M-9A0 (Calpella + N11P/M Discrete Graphic)

FOXCONN		HON HAI Precision Ind. Co., Ltd.	
		CCPBG - R&D Division	
Title ARD (CLK,MISC,JTAG)			
Size	Document Number	Rev	
Custom	M9A0 MP	1.1	
Date:	Thursday, November 19, 2009	Sheet	3 of 73

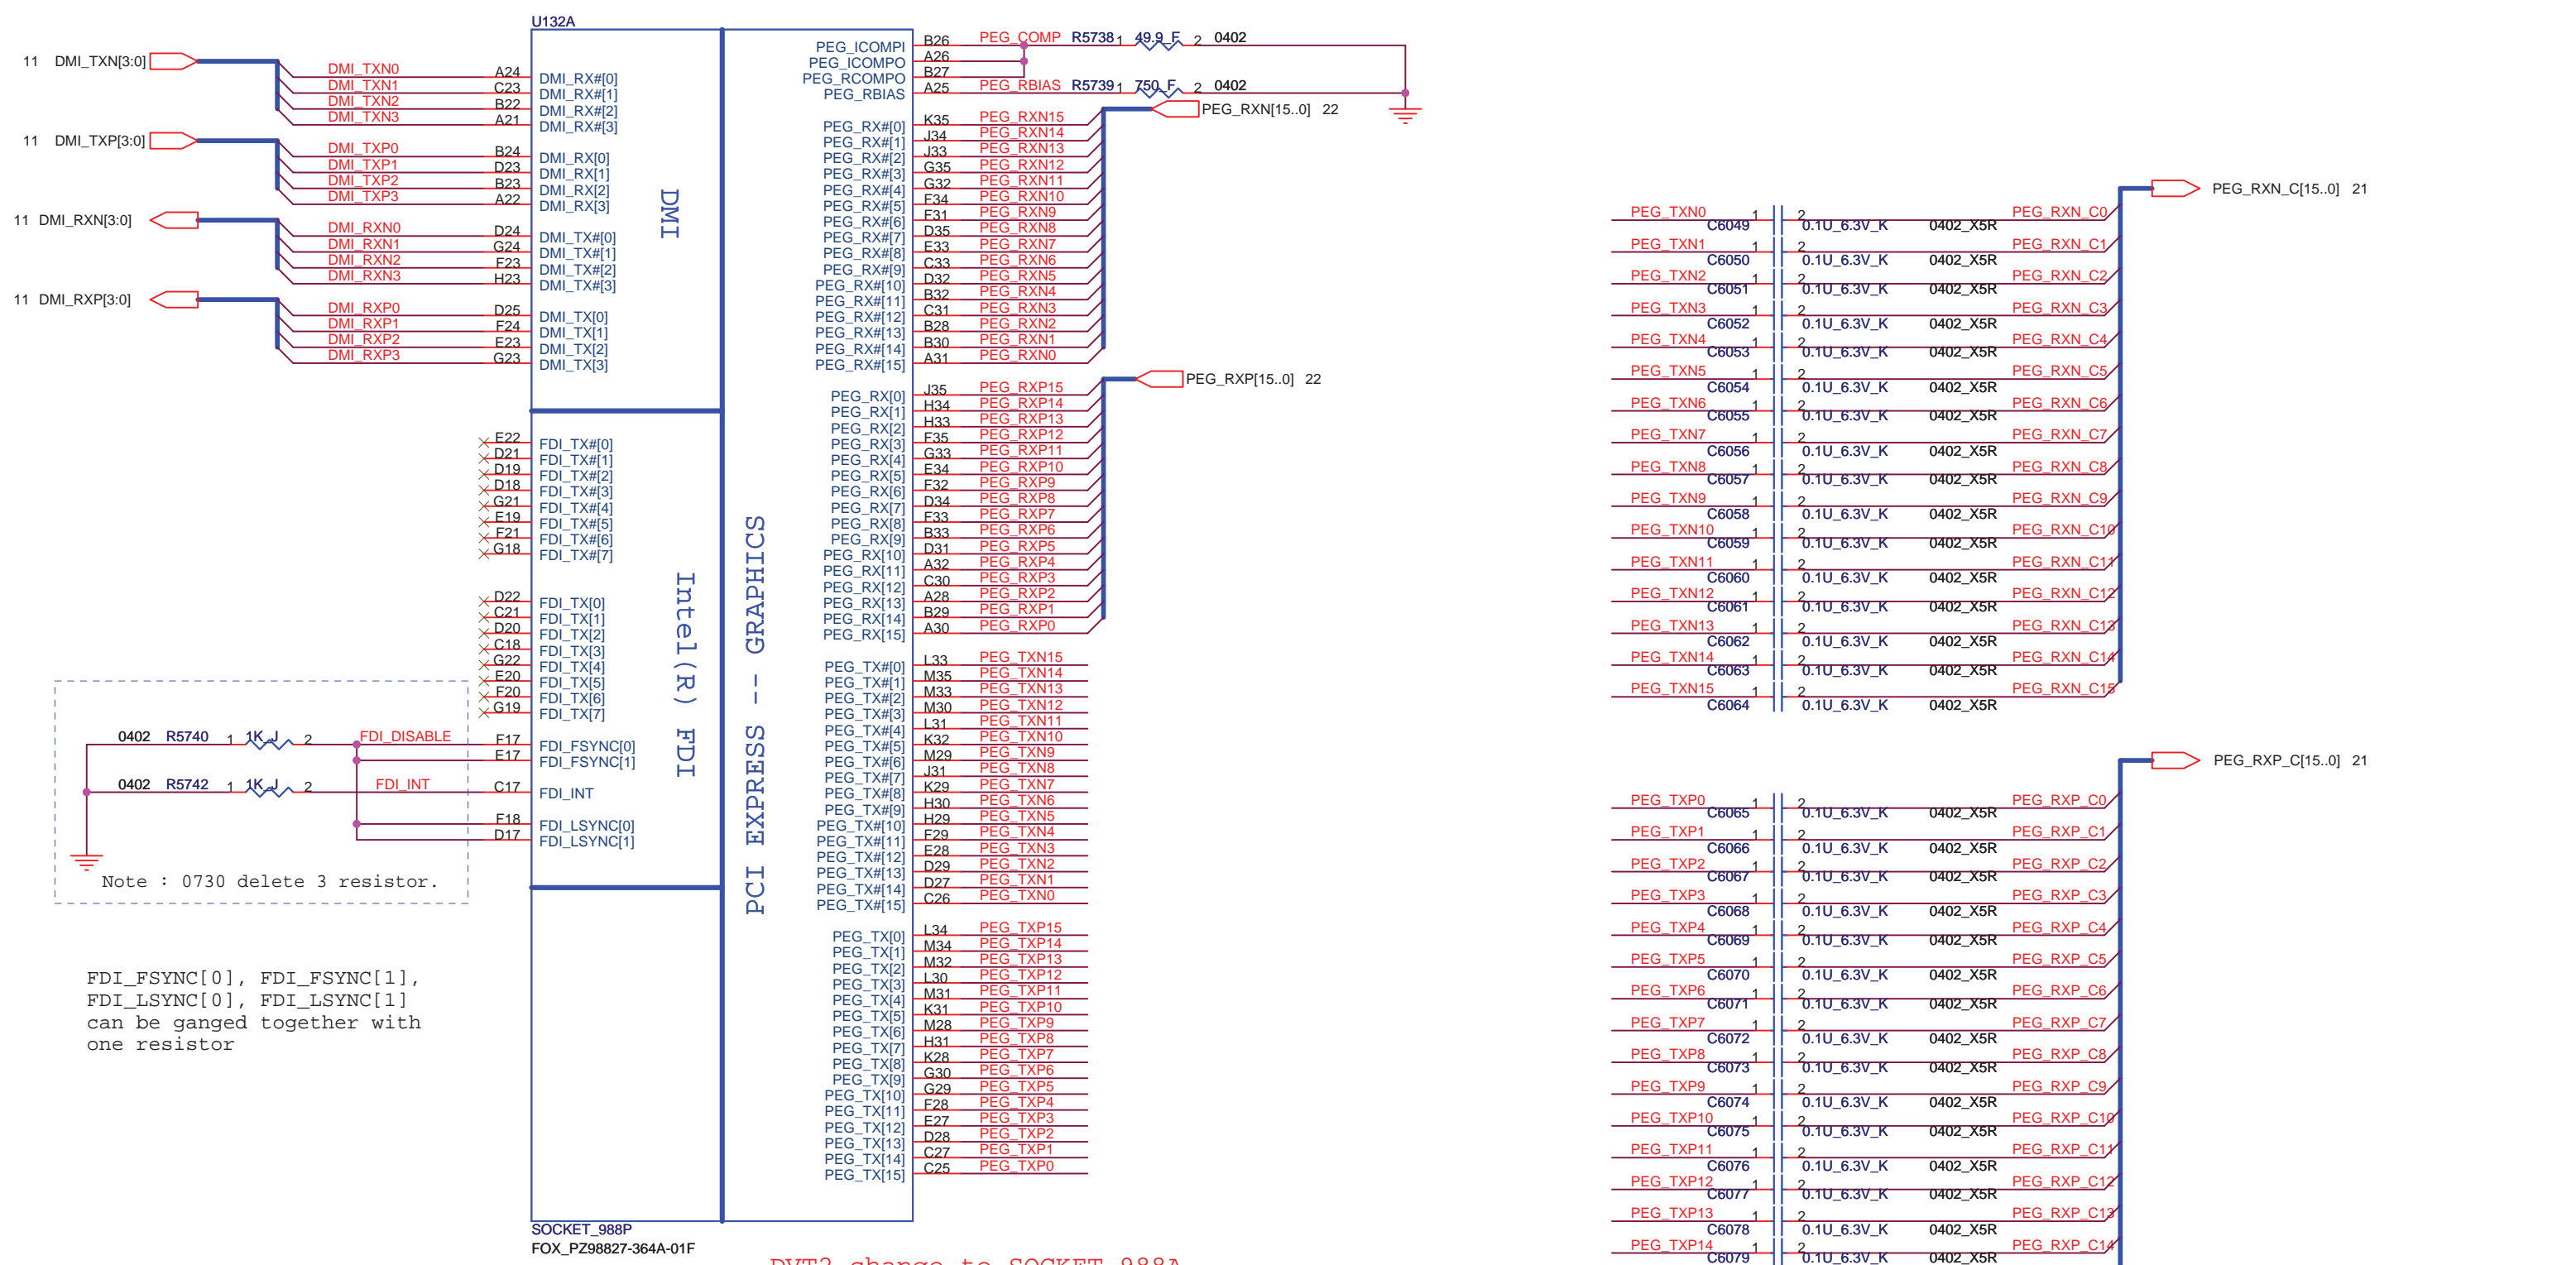
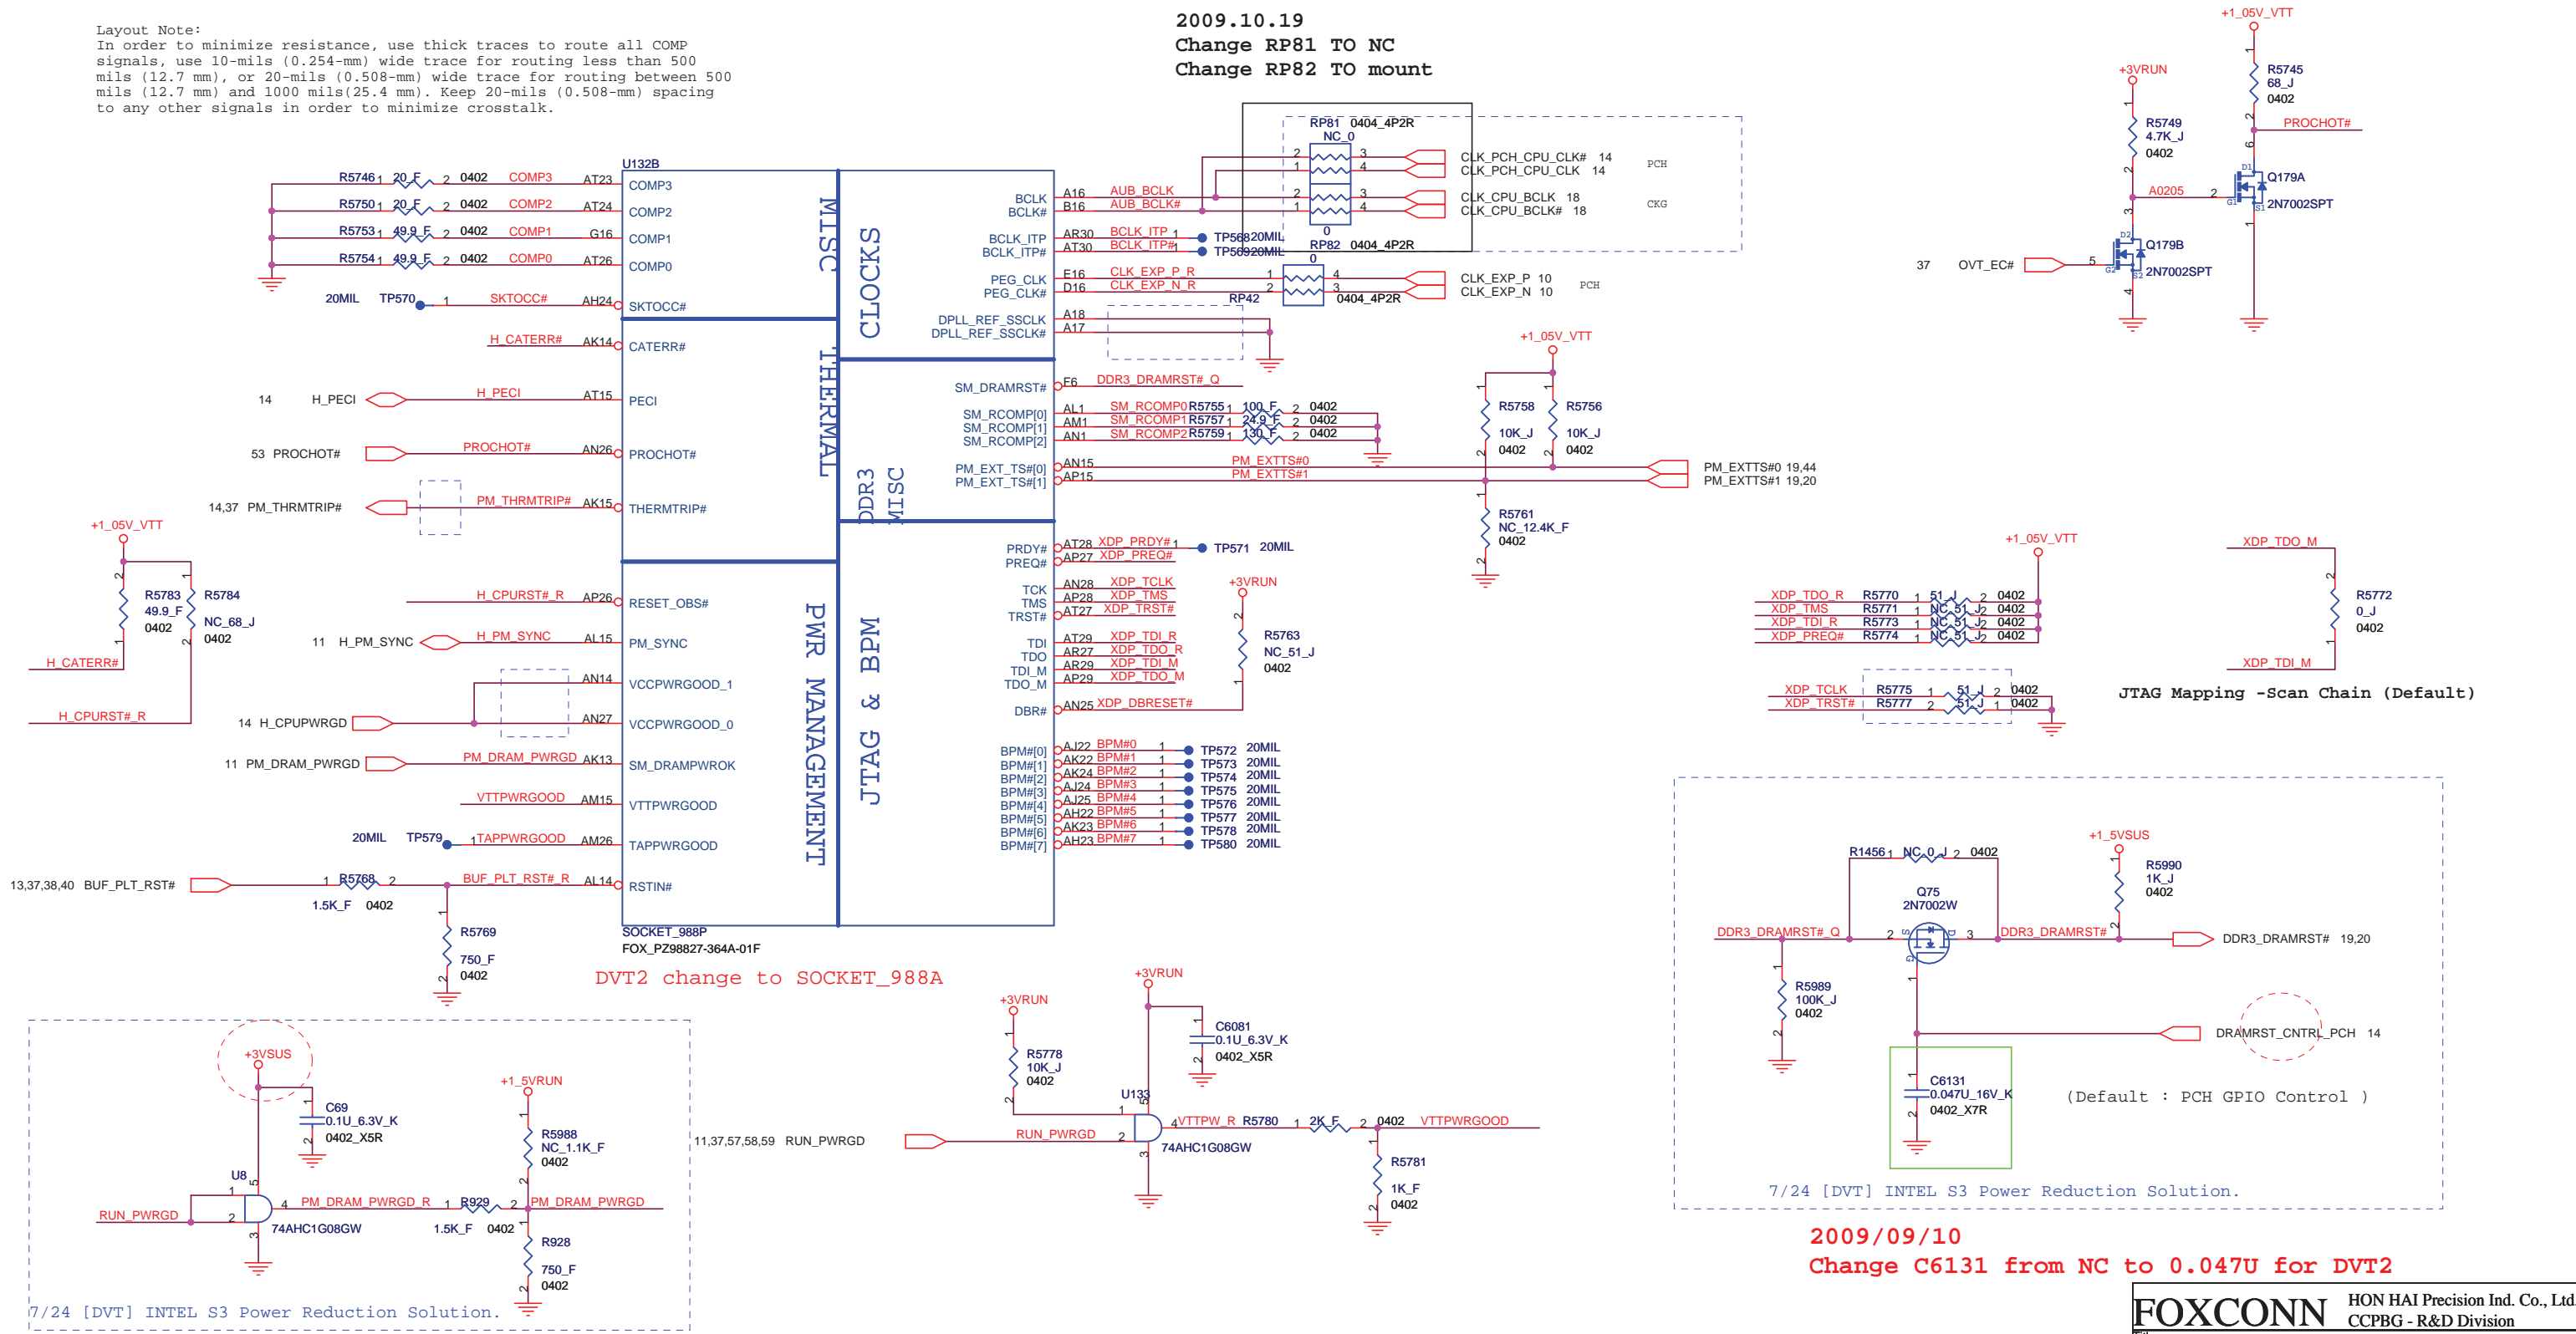
Note : 0730 delete 3 resistor.

2009.10.19
 Change RP81 TO NC
 Change RP82 TO mount

2009/09/10
 Change C6131 from NC to 0.047U for DVT2

FOXCONN		HON HAI Precision Ind. Co., Ltd.	
		CCPBG - R&D Division	
Title	ARD(POWER)		Rev
Size	Document Number	1.1	
Custom	M9A0 MP		
Date:	Wednesday, October 28, 2009	Sheet	5 of 73

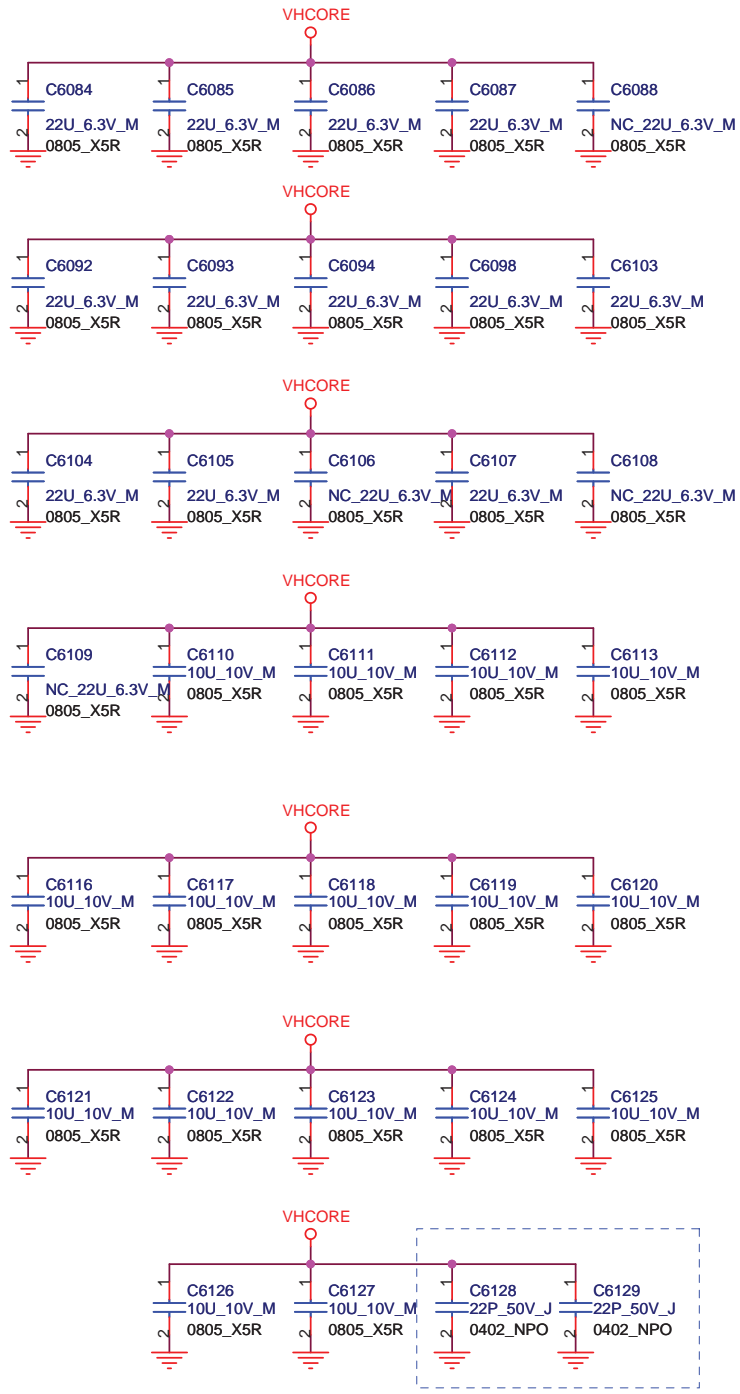
2009/09/12
Delete R5785 0ohm resistor for voltage drop problem

2009.10.23
Delete R5786 for PVT

FOXCONN		HON HAI Precision Ind. Co., Ltd.	
		CCPBG - R&D Division	
Title	PCH (PCI-E,SMBUS,CLK)		
Size	Document Number		
Custom	M9A0 MP		Rev 1.1
Date:	Friday, October 23, 2009	Sheet	10 of 73

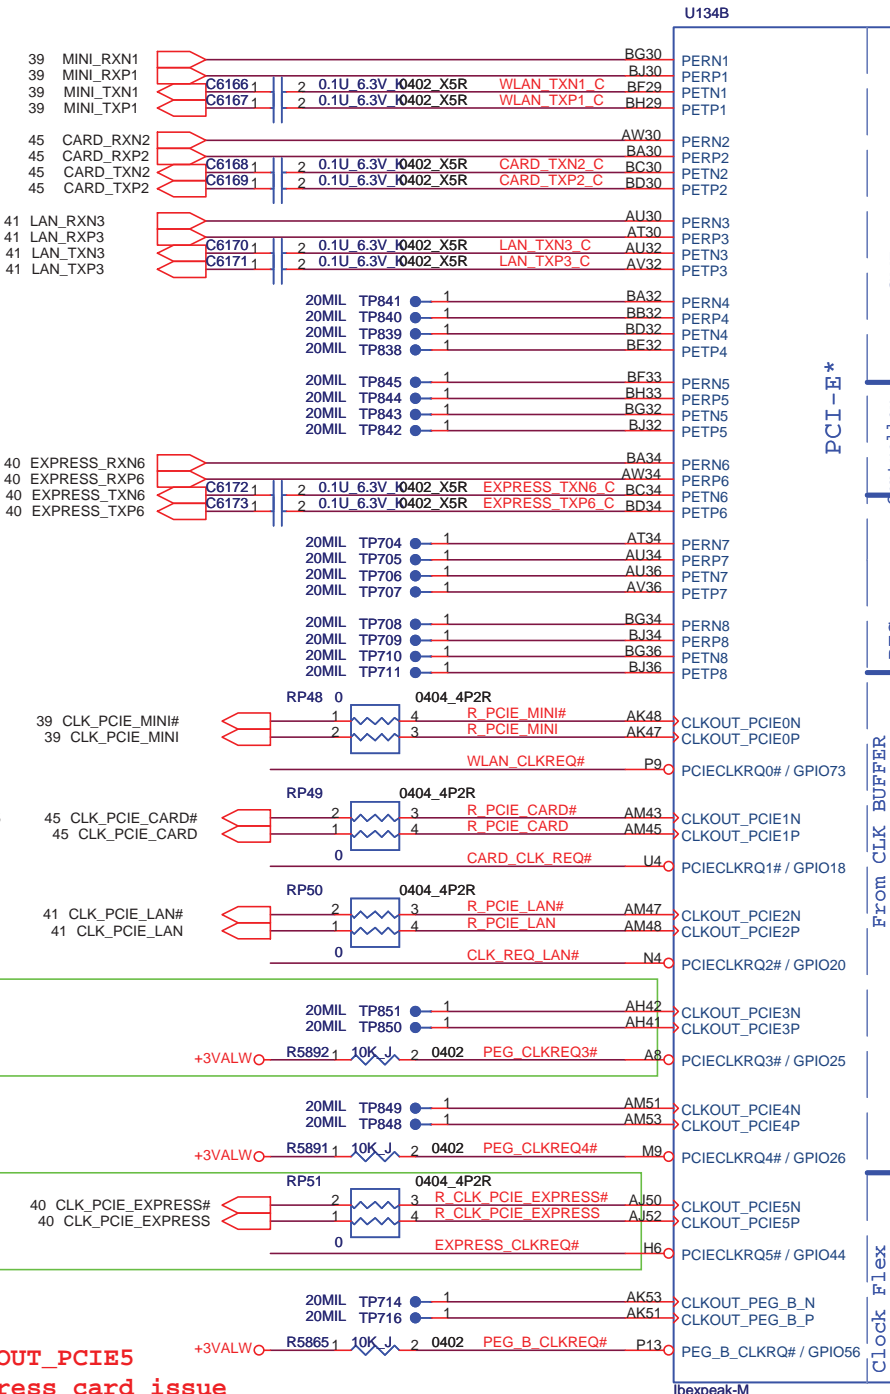
2009/09/10
 Remove PCI-E Express card
 differential clock to CLKOUT_PCIE5
 for DVT1 can't detect express card issue

FOXCONN HON HAI Precision Ind. Co., Ltd.		
CCPBG - R&D Division		
Title VGA (PCI EXPRESS) 1 OF 9		
Size	Document Number	Rev
Custom	M9A0_MP	1.1
Date:	Thursday, November 19, 2009	Sheet 21 of 73

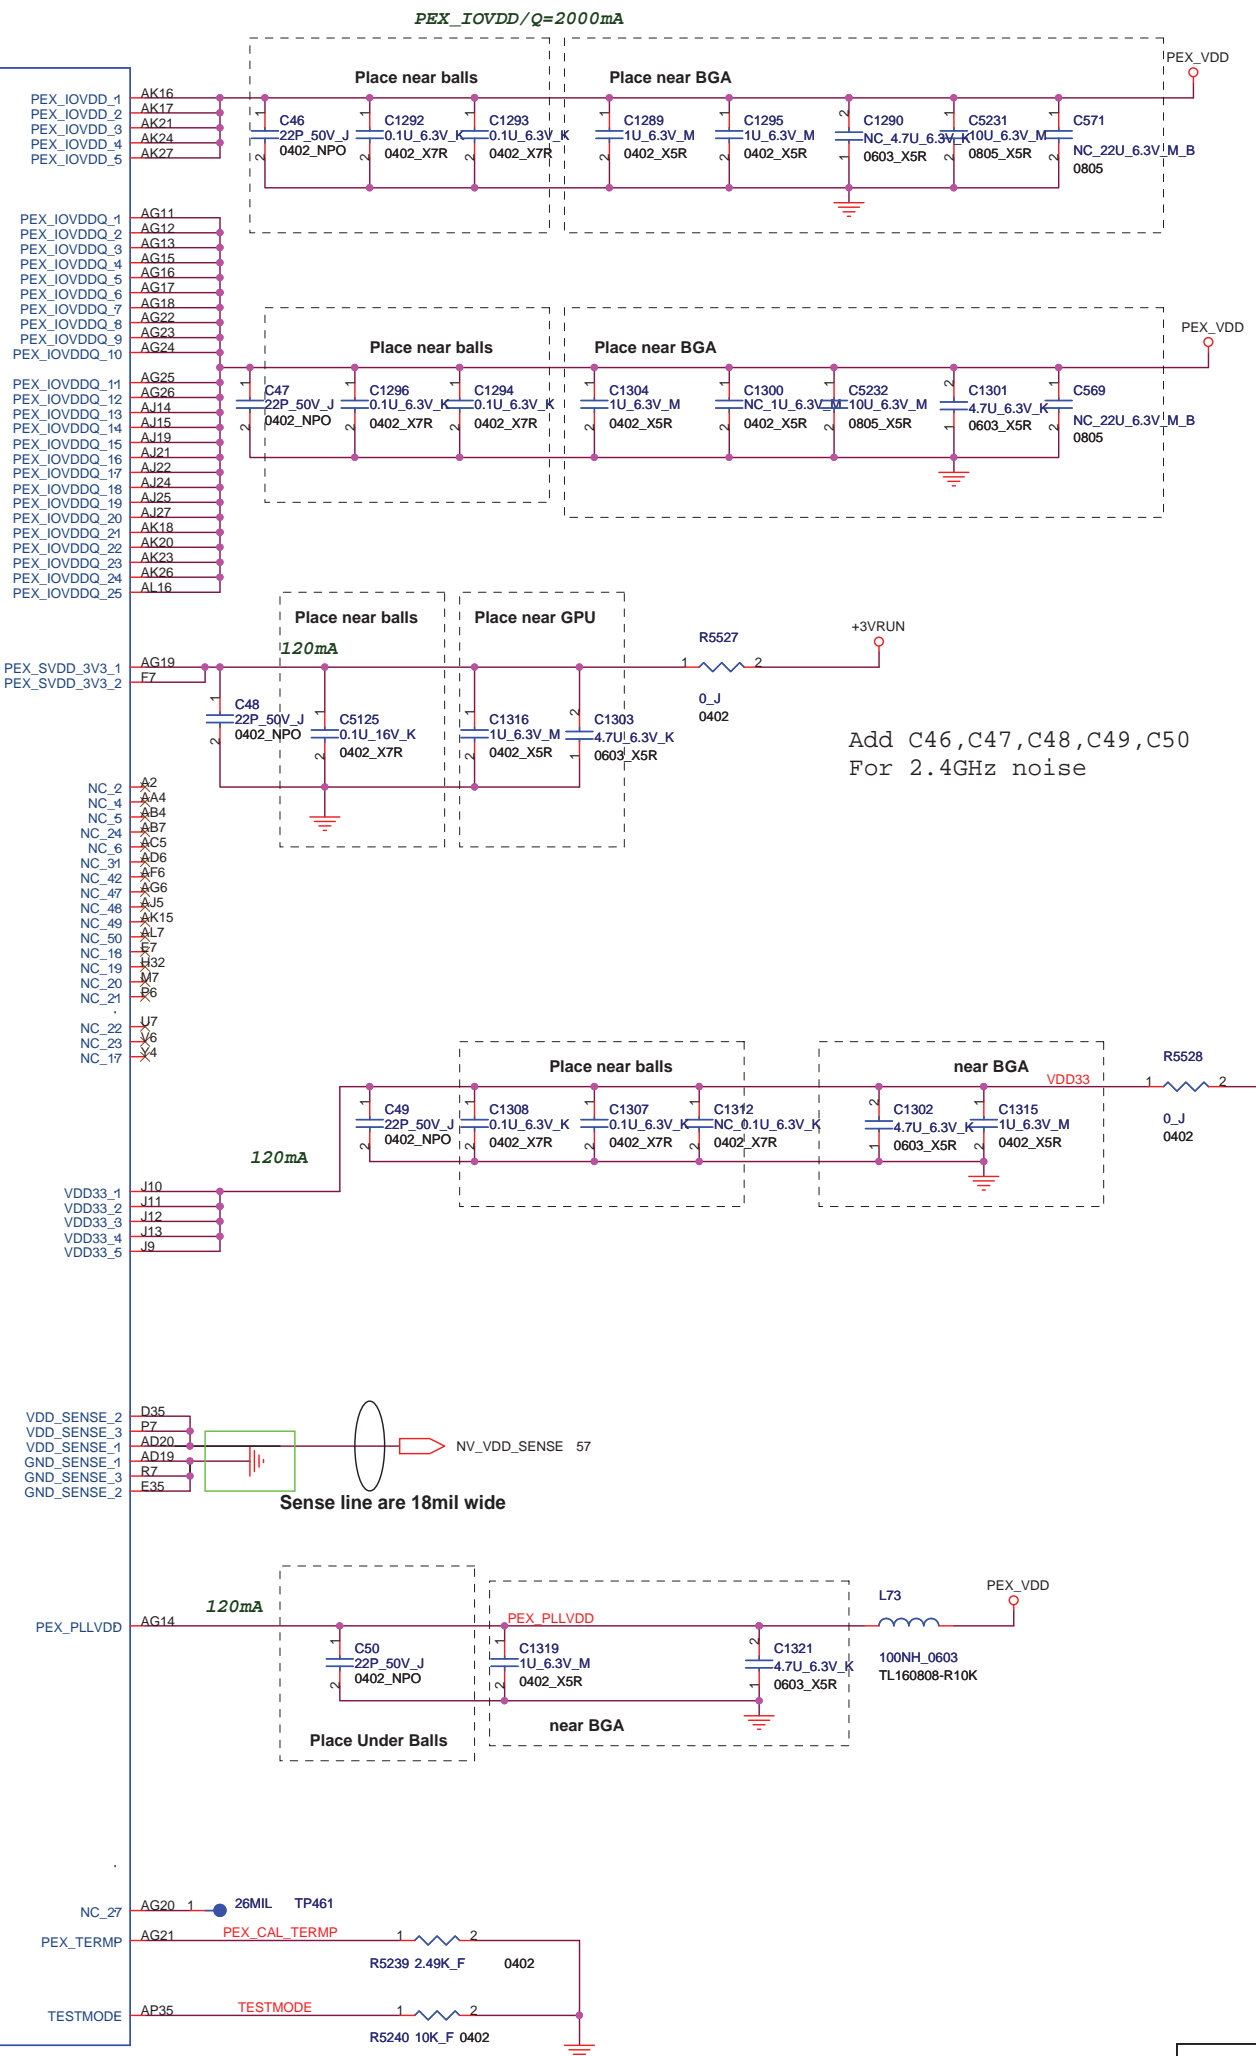
Add C46, C47, C48, C49, C50
For 2.4GHz noise
